DEVIATION REQUEST AND DECISION FORM

| Project Name : | Crossroads North |

A deviation from the standards of or in Appendix F, Standard Drawings, **SD 2-3, Urban Non-Residential Collector** and **Table 2-7. Roadway Design Standards for Urban Collectors and Locals-** of the Engineering Criteria Manual (ECM) is requested.

SCALE: NOT TO SCALE

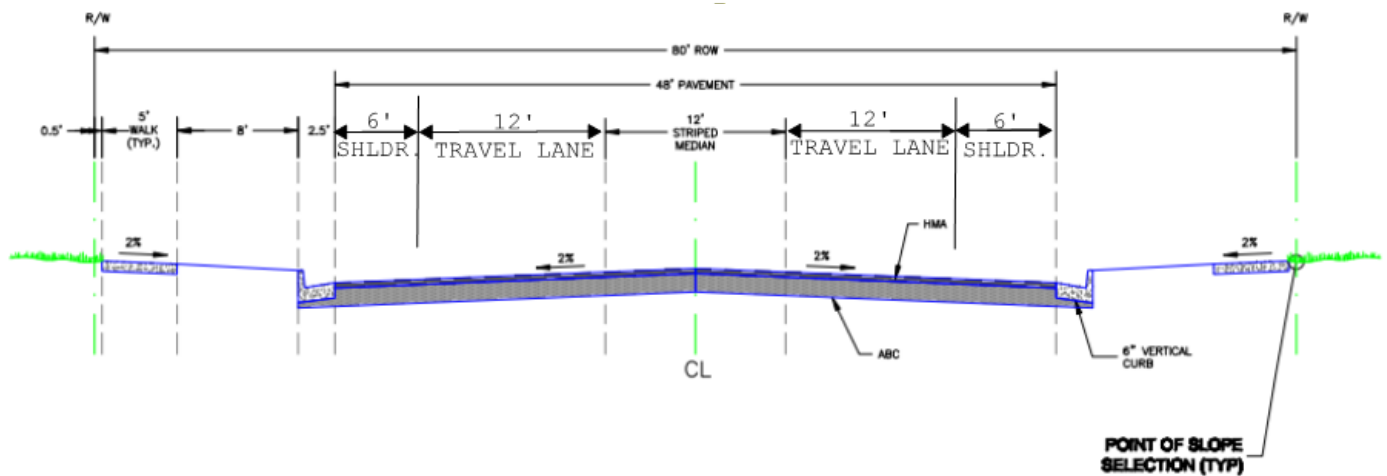
Please coordinate with the project planner as to the proposed tract width for the private roads and update accordingly as it is not consistent between the preliminary plan sheets.

Also please clearly state what is being deviated from from each of the roadways (Pro Omnibus & Nox Album) as they each have a different cross section. For instance only Nox Album point will have a 36' paved width as Pro Omnibus has a 48' paved width matching criteria.

It appears the only differences from criteria for Pro Omnibus would be the centerline radius, tract width, design speed, and direct lot access (please verify any others that i missed).

remove as each lot access will be reviewed as applications are submitted.

revise to indicate all lots along pro Omnibus as it appears that all lots will potentially have access to this private non-residential collector roadway.
